**MUNICIPAL PLANNING COMMISSION AGENDA  
SUMMER VILLAGE OF BIRCHCLIFF  
SUMMER VILLAGES ADMINISTRATION OFFICE  
MAY 18, 2023 @ 1:00 P.M.**

### 71 Birchcliff Road (Lot 2, Block 4, Plan 4486AX)

### Development Permit Application

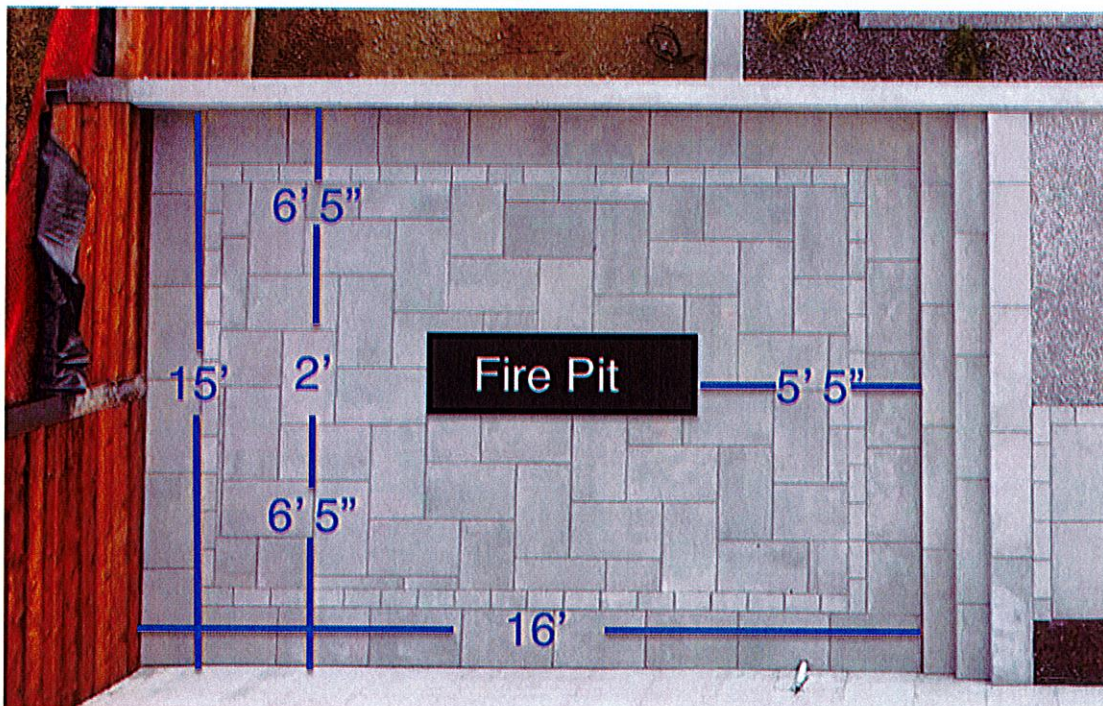
Tier 1 (Lower). This is the boat lift/dock storage area. The approved permit indicates that *"The entire lowest tier adjacent to the lake to be a no mow zone of native grasses and shrubbery, no beach or sandy area permitted"*. This area will be a no mow zone and left to naturally revegetate.

Tier 1 (Upper) This tier has a combination of paving stones and natural rundle stone. The pavers serve as a walk way from the stairs to access the dock and the dock/lift storage area. We have elderly parents that spend a lot of time with us and require accessible access to the lake. We planted 32 shrubs and grasses on the perimeter of this tier. Natural vegetation can also grow in the areas amongst the rundle rock.

Tier 2 This tier is a combination of a lowered fire pit area and a turfed lounging area. The fire pit area was recessed 2' for protection from the wind. The size of the wood burning fire pit is approx 2' x 4'. Permeable paving stones were installed surrounding the fire pit as per the National Fire Code which states that a 2 meter stone perimeter is a safe flame protective perimeter.

The lounging area of Tier 2 includes stone pavers that access the fire pit area, a turfed area for lounge chairs and perimeter planting of 5 shrubs.

Lowest Tier

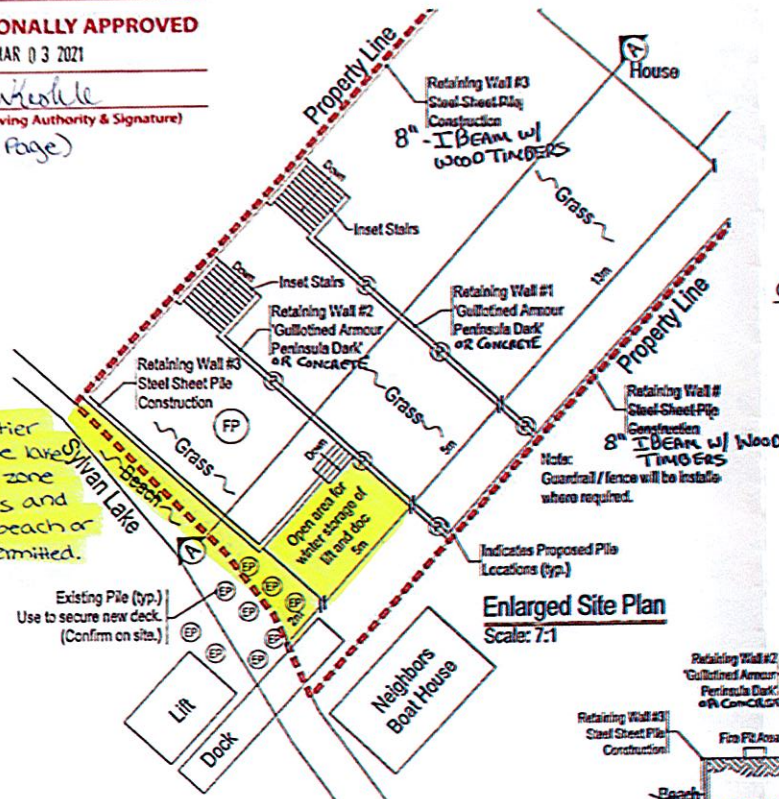
- **Tier levels** - On the original drawing (Schedule B) it appears the winter storage area is on the same level as the beach, there is no elevation difference shown. This was all considered the lowest tier and as it was shown on the drawings as “beach”. MPC referenced beach in the condition as that is what was proposed in the area (Schedule A).

The current application before MPC notes a tier 1 (lower) and (upper) which was never shown on the original drawings. As referenced in the applicant’s current

submission, what is classified as tier 1 (lower) was approved to be a no mow zone and tier 1 (upper) was approved to be grass only. It appears that the applicant is referring to both tier 1 (upper) and (lower) as a no mow zone. However, a no mow zone is a buffer strip or area of vegetation that includes native plantings that let aquatic vegetation grow to maintain a stable natural state. A no mow zone allows native plants to seed and re-establish and is not to be maintained. As noted on the original approved drawings, it is meant to be filled with native grasses and shrubs. What is currently in place is not what we would consider a no mow zone, however, tier 1 (upper) was approved to have grass in the original application.

Condition #10 on DP.

Other tiers

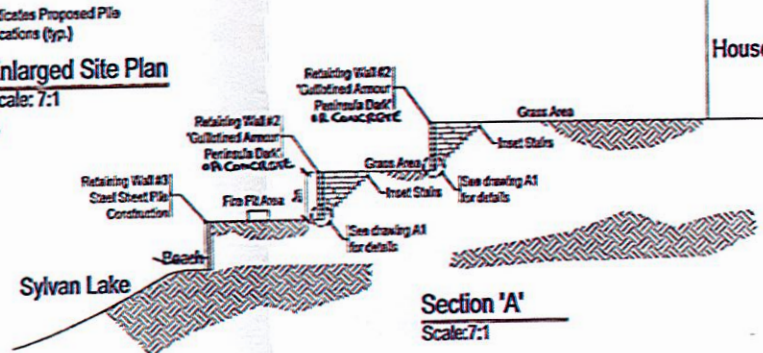
- **Landscaping** – The approved documents show grass on every tier except the lowest winter storage and beach area which was to be a no mow zone (Schedule C). Condition #11 in the development permit also states, *“Tiered areas between retaining walls to be grass which could include a rock/stone perimeter around the firepit”*. This is clear that the tiers are to be entirely grass as shown in the proposed/approved drawings.
- **Firepit area** – (Schedule D) Condition #11 of the development permit states *“Tiered areas between retaining walls to be grass which could include a rock/stone perimeter around the firepit”*. The proposed and approved drawings show a small circular firepit location that the MPC gave permission to have a perimeter around. In our opinion, the perimeter would be only as significant as the small circle shown on the drawings.

Condition #11 on DP.

# SCHEDULE D

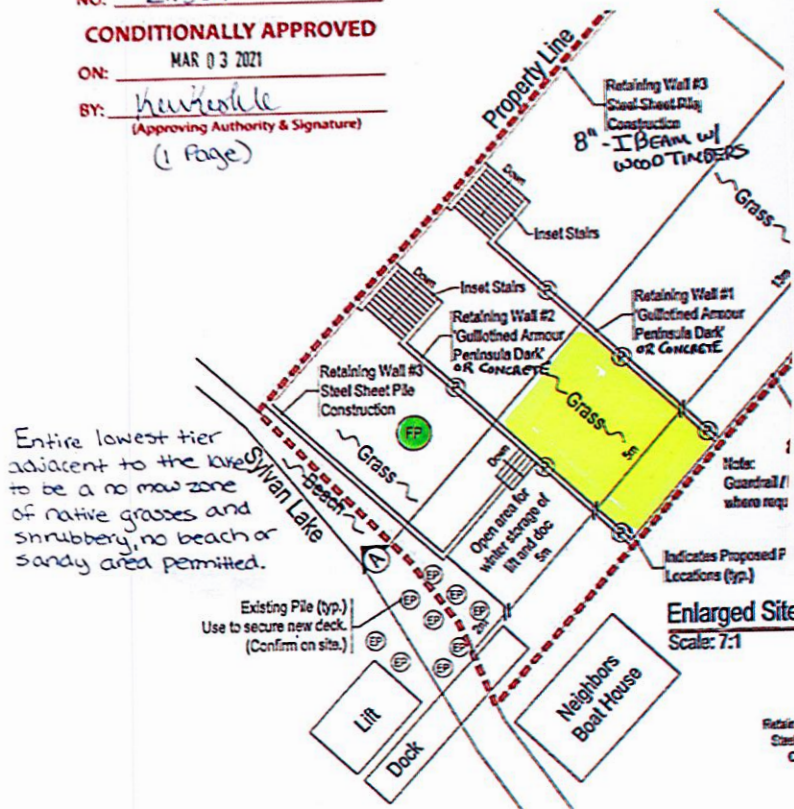
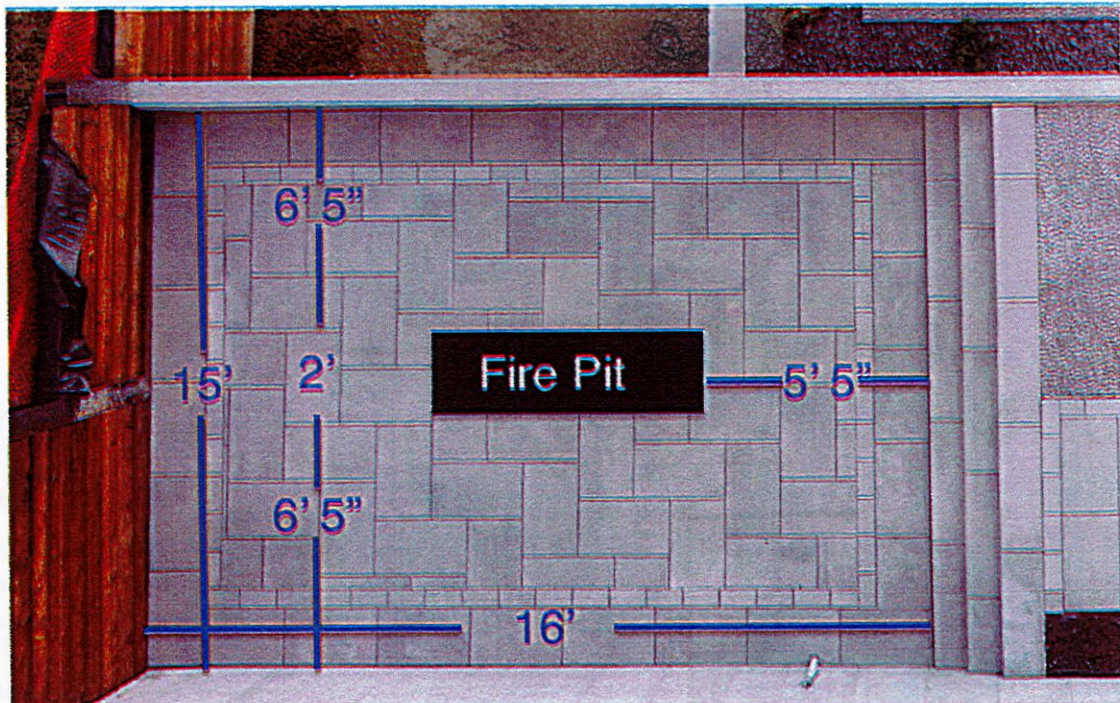
What was originally approved was a small circular firepit area. What was constructed appears to be a 240ft<sup>2</sup> stone patio that is not required by Fire Code or the Birchcliff Fire Pit Bylaw. While the relocating of the fire pit to another tier may be an acceptable minor amendment, the substantial enlargement of the hard landscaped area is not.

Firepit area proposed

Constructed

Location retaining wall exceeds maximum

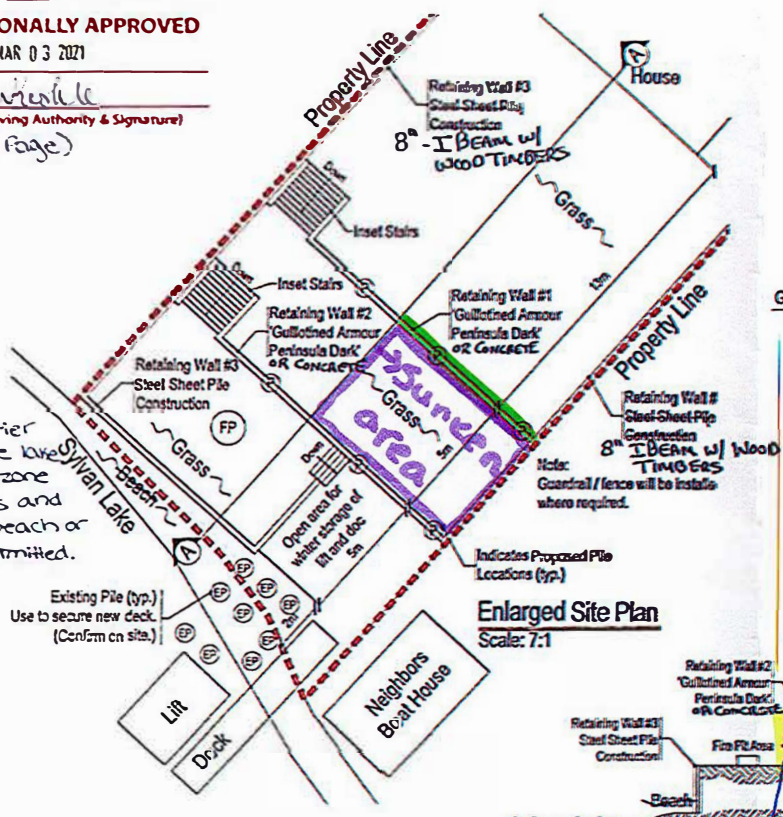
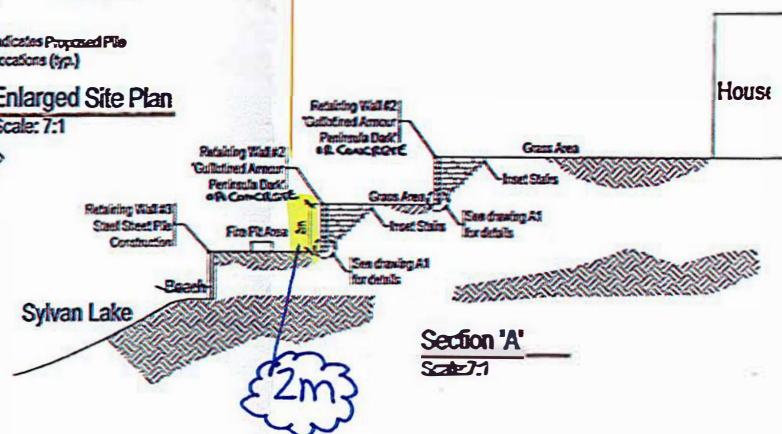
- **Retaining Walls** – The proposed and approved drawing shows a cross section of the tiers (Schedule E). The cross section shows each of the walls are the same height, with the exception of the wall along the winter storage area as there are stairs going down to that lower area.

As the currently constructed firepit area was recessed, the height of that retaining wall is now 2.4m.
